## PCN – Process Change Notification

Change:	WLP.2450.25.4.A.02
Date:	2016/08/16
Author	Bonnie Chen

Model#	Part Number	Changes
WLP.25 Patch Antenna	WLP.2450.25.4.A.02	Packaging rules changing.
		Add Part no.
		Amend length of pin from 2.25mm to 2.27mm.
		Amend Dimensions and Tolerance.

### New packaging rules

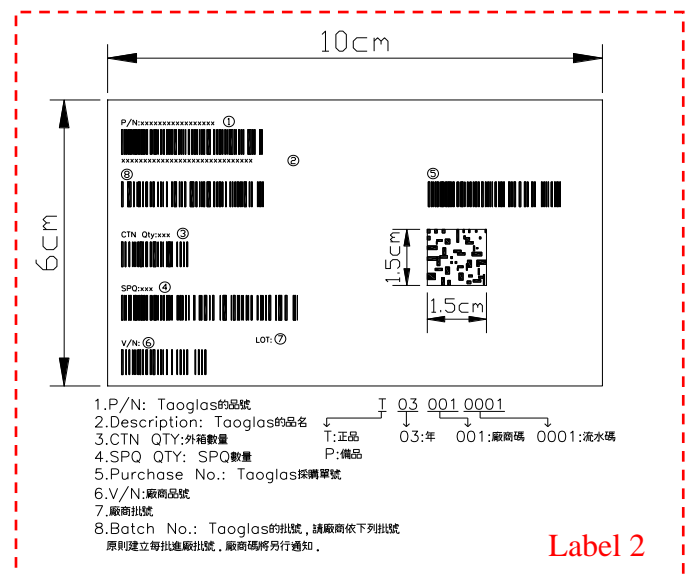
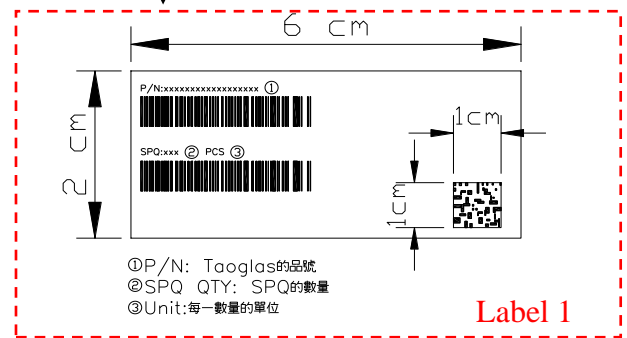
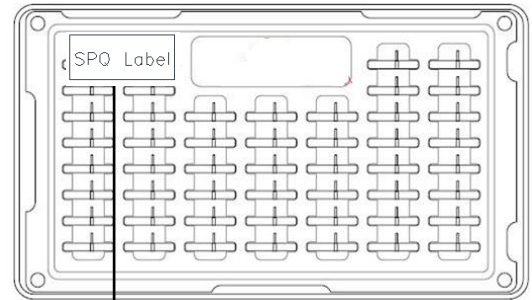
200PCS on tray and  
Into per small box

4 small boxes

800 PCS per big carton  
330\*280\*270mm

New Part No. BOM & Patch Size & Length Of Pin

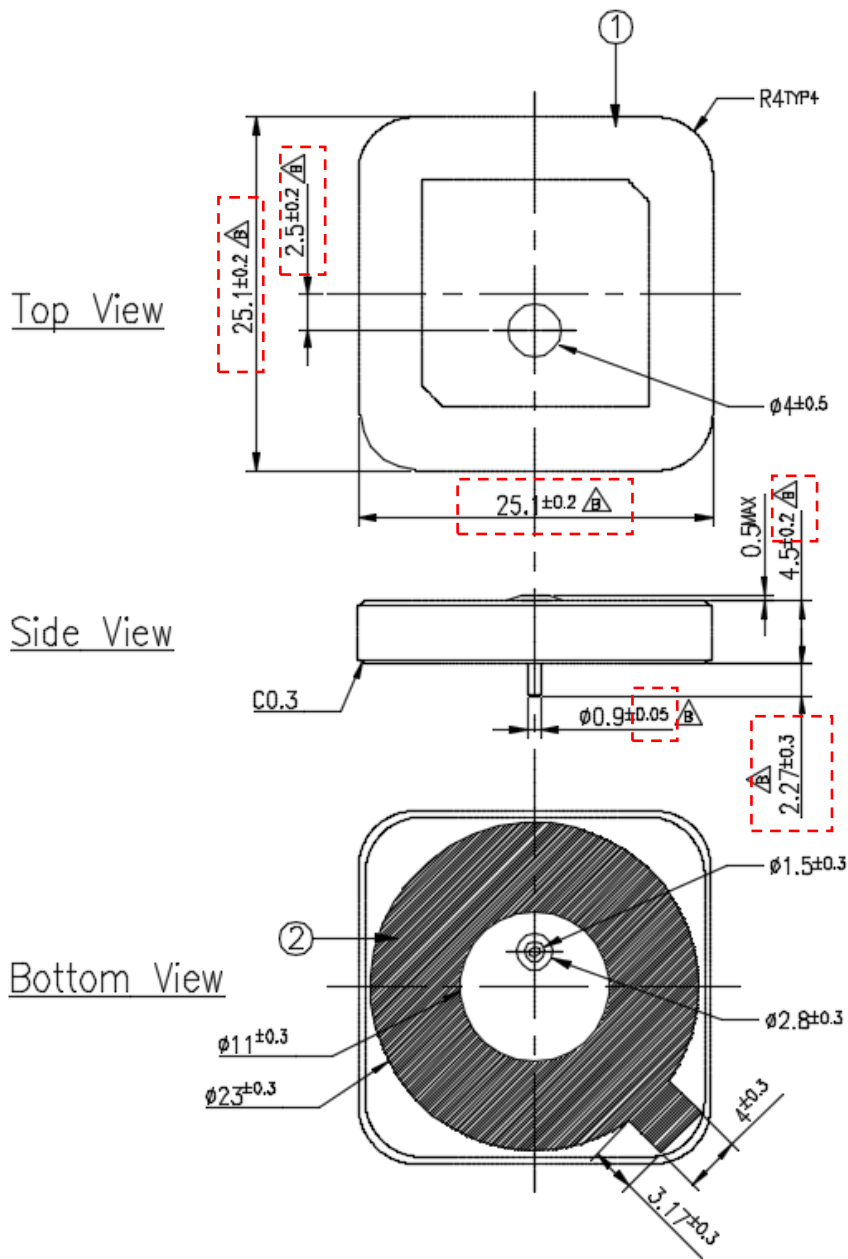
1. Due to Taoglas will input Barcode tracking process, we need to amend the packaging rules and labelling on barcode labels on standard packaging quantity bag and cartons.
2. Amend part no. on bom.
3. Amend length of pin from 2.25mm to 2.27mm
4. Amend Patch Size from 25x25mm to 25.1x25.1mm
5. Amend Tolerance.

Name	P/N	Material	Finish	QTY
1	WLP.2450 Patch (25x25x4.5mm)	001513B080007A	Ceramic	Clear	1
2	Double Sided Adhesive	001013C130007A	NITTO 5015	White Liner	1
